Cogburn Sand, Gravel, and Reservoir Project Adequacy Review Letter

Re: Cogburn Sand, Gravel, and Reservoir Project, File No. M-2025-016, 112 Construction Materials Reclamation Permit Application, Preliminary Adequacy Review

Exhibit B- Mule Deer Migration Corridor indicated in striped red wine.

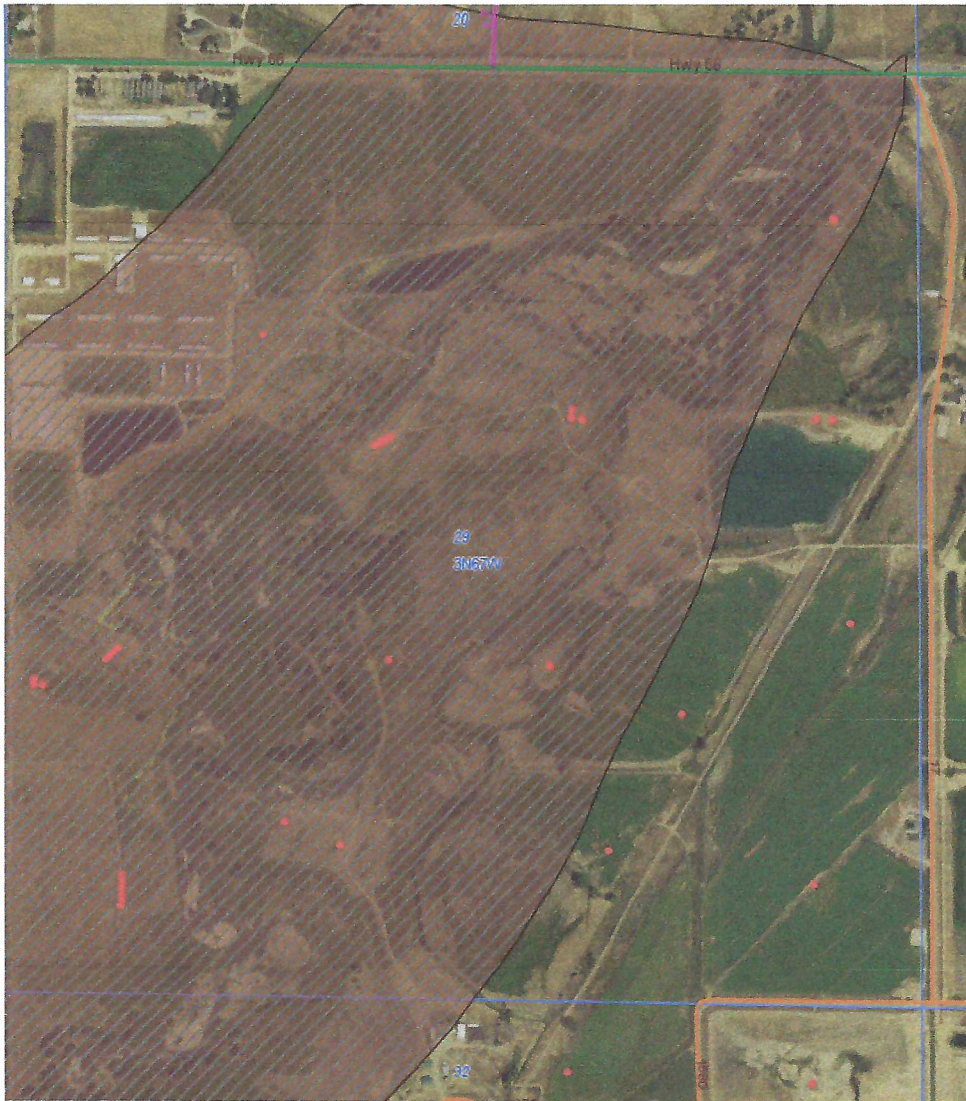
CPW recommends avoiding the riparian corridor to the maximum extent possible to keep the migration corridor along the river as open as possible. CPW agrees with ERO's recommendation that states *"The creek drainage will be undisturbed and remain open to maintain suitable habitat year-round, including severe winter weather, and provide movement corridors to the northwest of the mine area"*. In particular, a Mule Deer Migration Corridor occurs along the St. Vrain Creek Corridor on the western side of the project, as shown in Exhibit B.

Exhibit C- Bald Eagle Active Nest Site indicated in striped peach (½ mile buffer), striped pink (¼ mile buffer) and solid red (½ mile buffer around new nest).

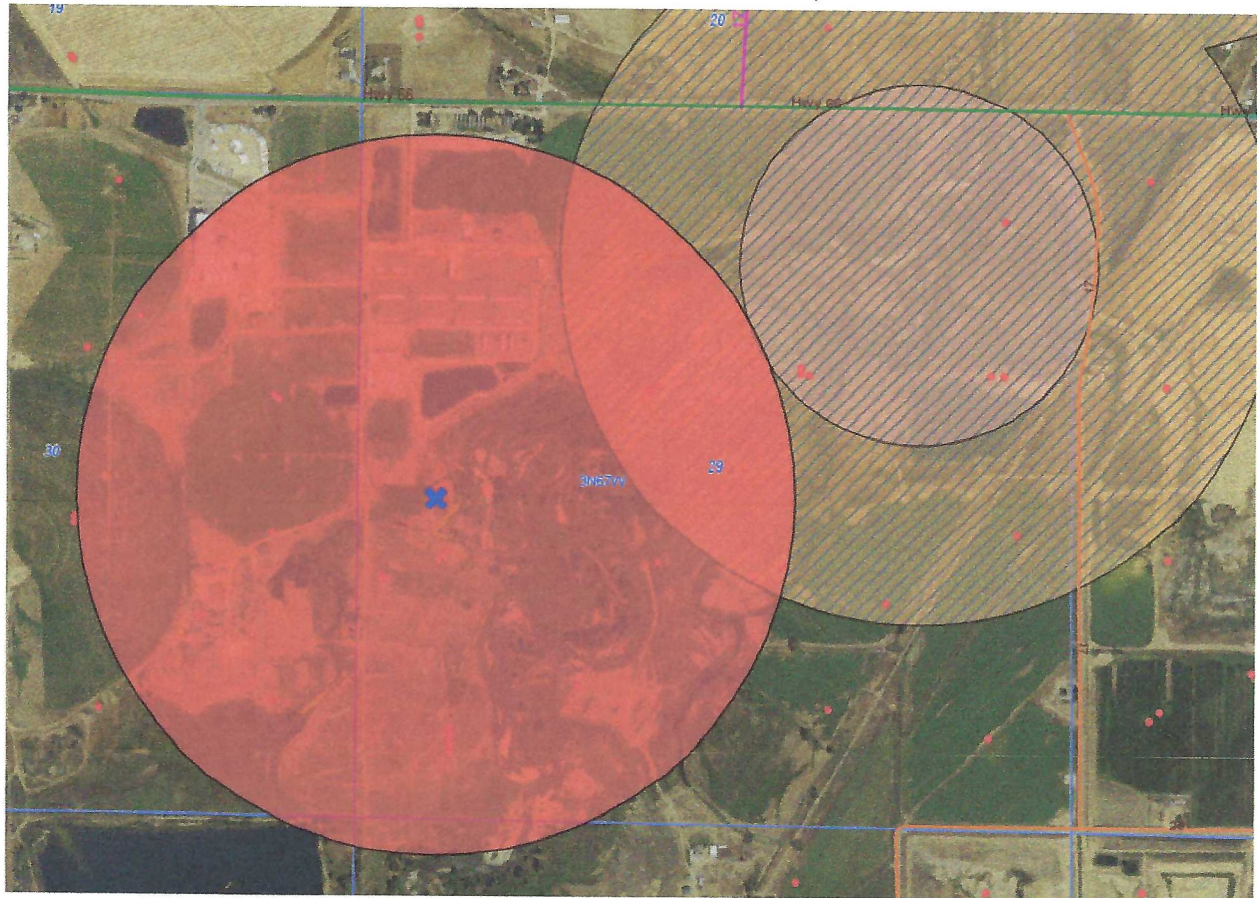
In particular, there are bald eagle active nest sites around the project site as shown in Exhibit C. There is a new nest mapped as of March 1st, 2025, the ½ mile buffer is shown in red below. CPW recommends avoiding these areas when expanding the project footprint.
